ELEVATED WALKWAY NO. 1 AND STAIRS NO. 1

GENERAL NOTES
PONCE DE LEON AVENUE/ATLANTA
BELTLINE CONNECTION RAMP
FULTON COUNTY 0012586

DATE	03-11-20
	REVISIONS	TO ALUMINUM GRATING

DATE	03-11-20
	REVISIONS	
BY	REVISOR	TO
AS	REVISED STAINLESS STEEL GRATING TO ALUMINUM GRATING	
DRAWING NO. 35 - 0009 BRIDGE SHEET 9 OF 11

FRAMING PLANS - RAMPS
PONCE DE LEON AVENUE/ATLANTA
BELTLINE CONNECTION RAMP
FULTON COUNTY

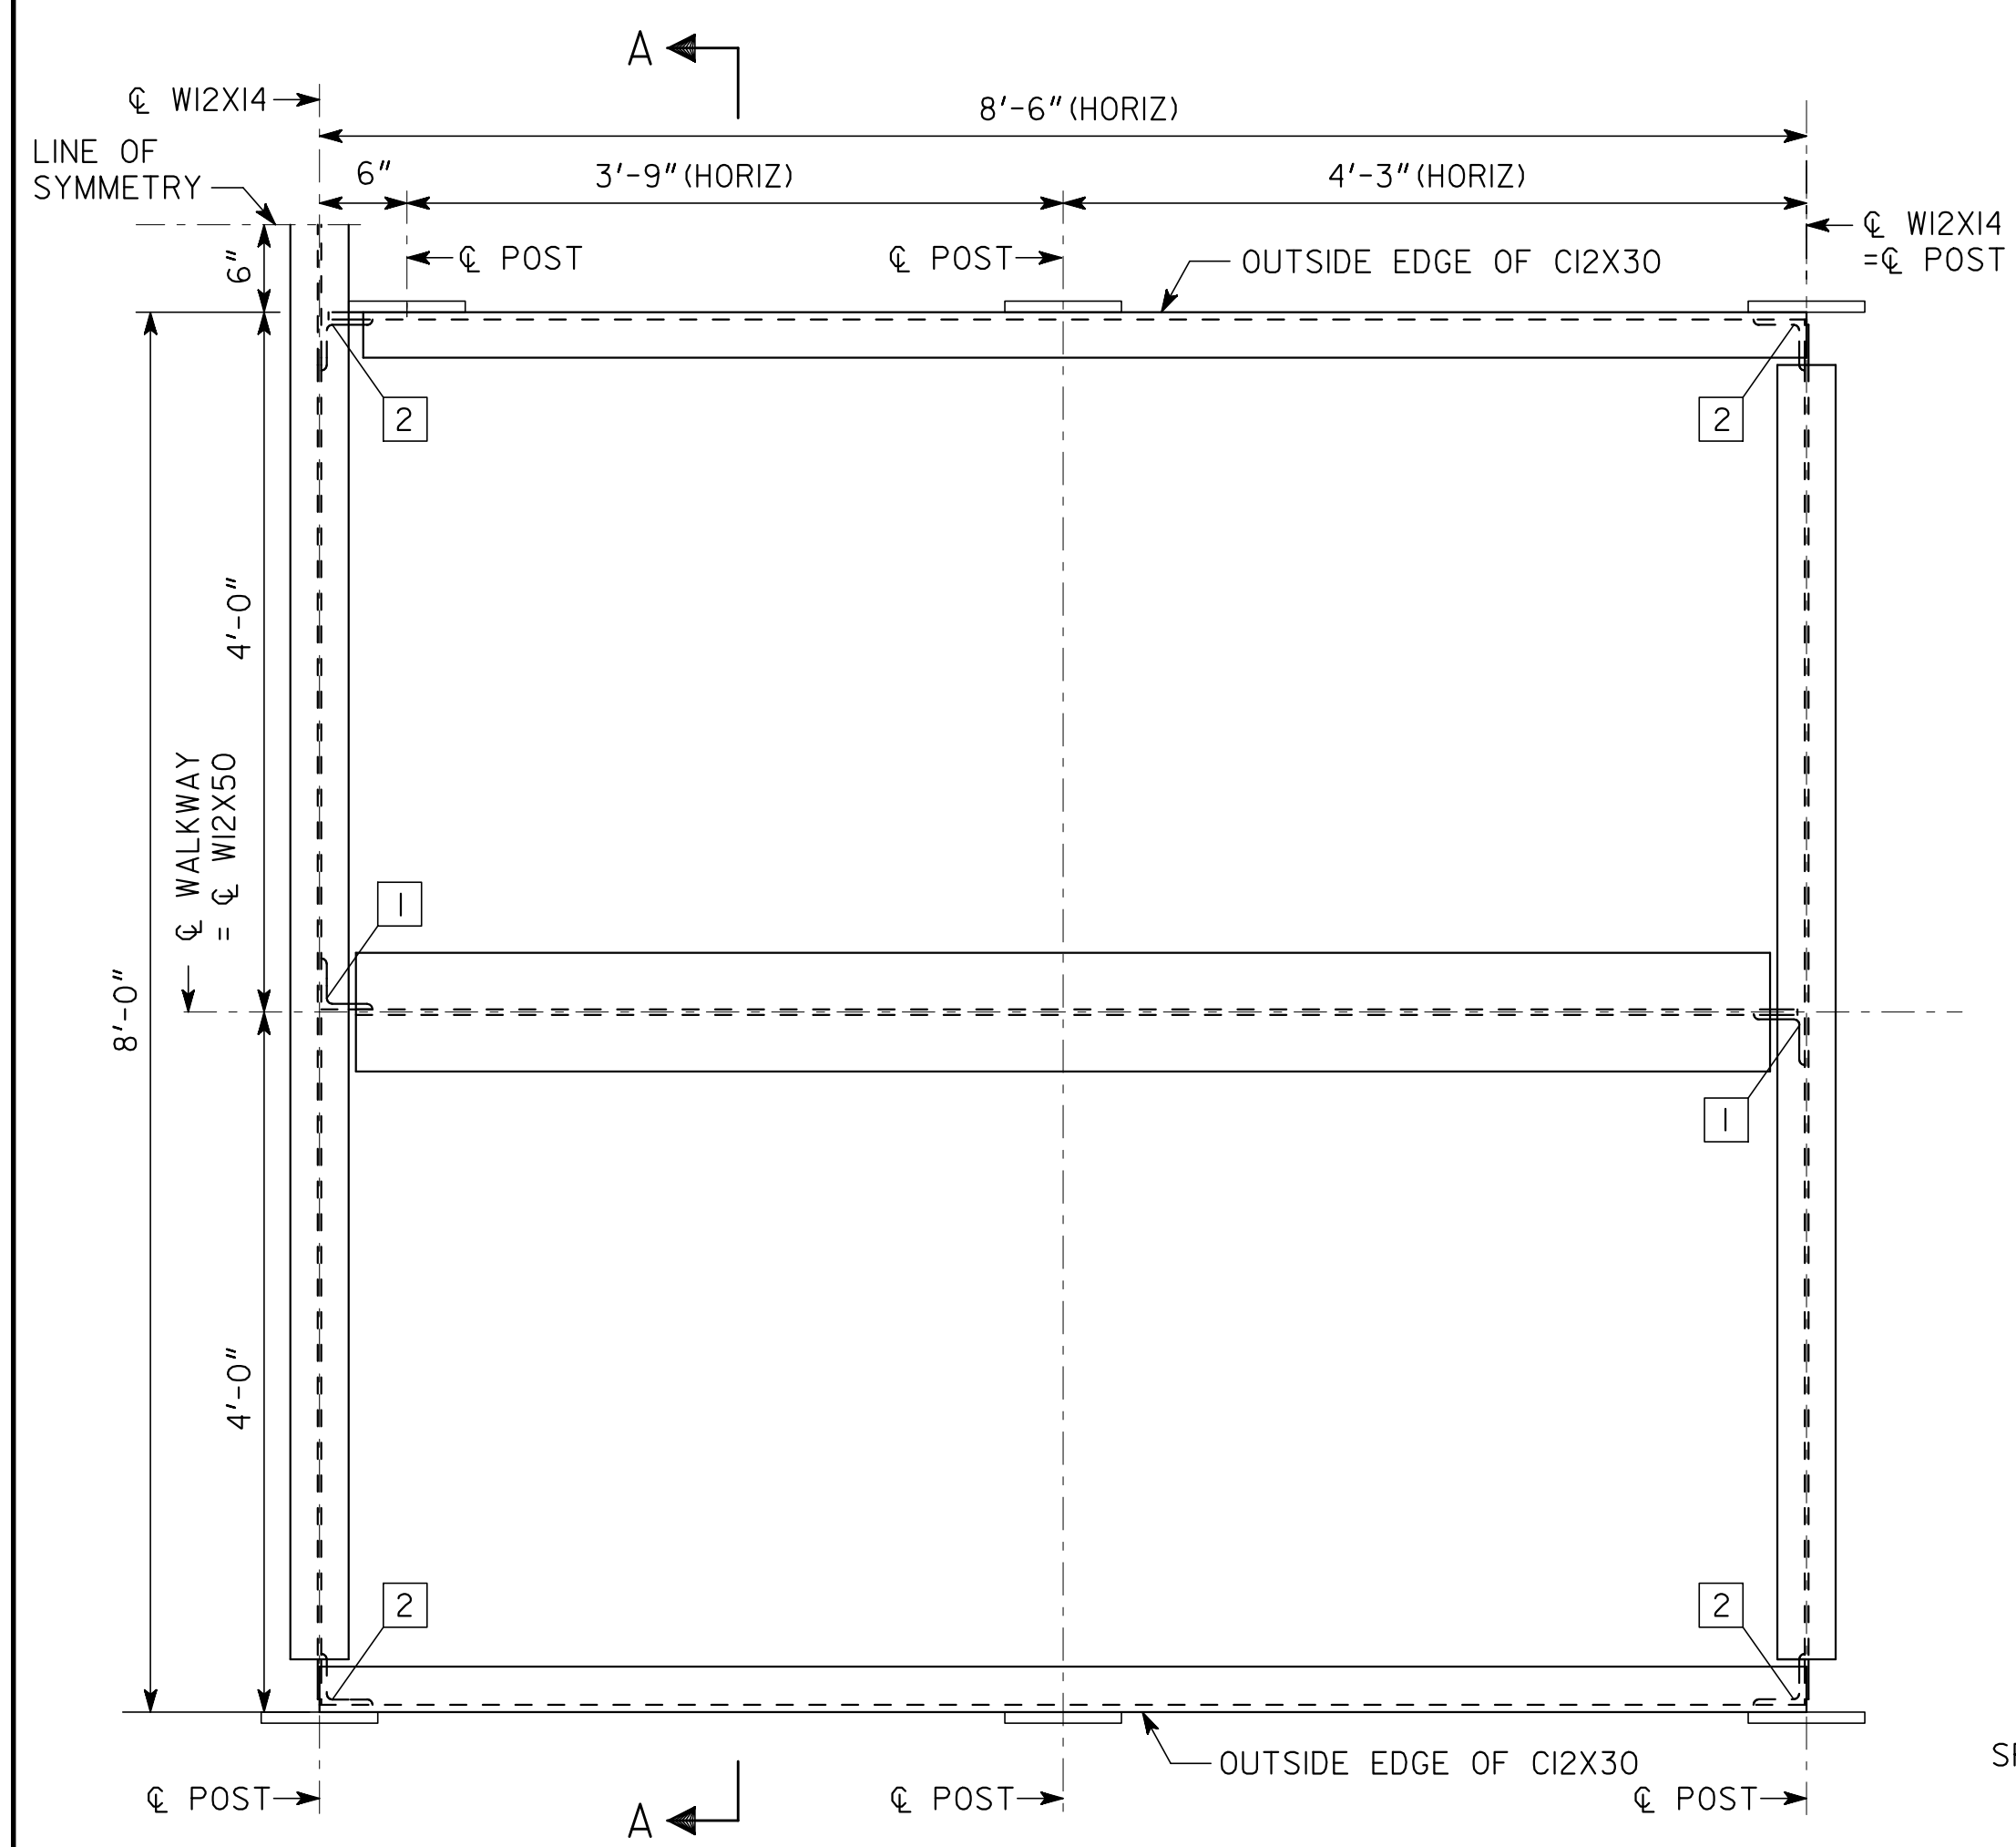
DATE	03-11-20
	REVISIONS	
BY	AS	TO ALUMINUM GRATING
DRAWING NO.	35 - 0005	
BRIDGE SHEET	5 OF 11

- ALUMINUM GRATING SHALL BE A SWAGE-LOCKED, T-BAR STYLE, GRATING WITH 19-S-4 SPACING, BAR SIZES SHALL BE 1" X 0.940" WITH A GROOVED SURFACE (NON-SERRATED), OR APPROVED EQUAL. GRATING CONNECTIONS SHALL BE PER MANUFACTURER'S RECOMMENDATION.
- TEFLON ISOLATORS SHALL BE USED TO ISOLATE ALUMINUM GRATINGS FROM STRUCTURAL STEEL SUPPORTING COMPONENTS.
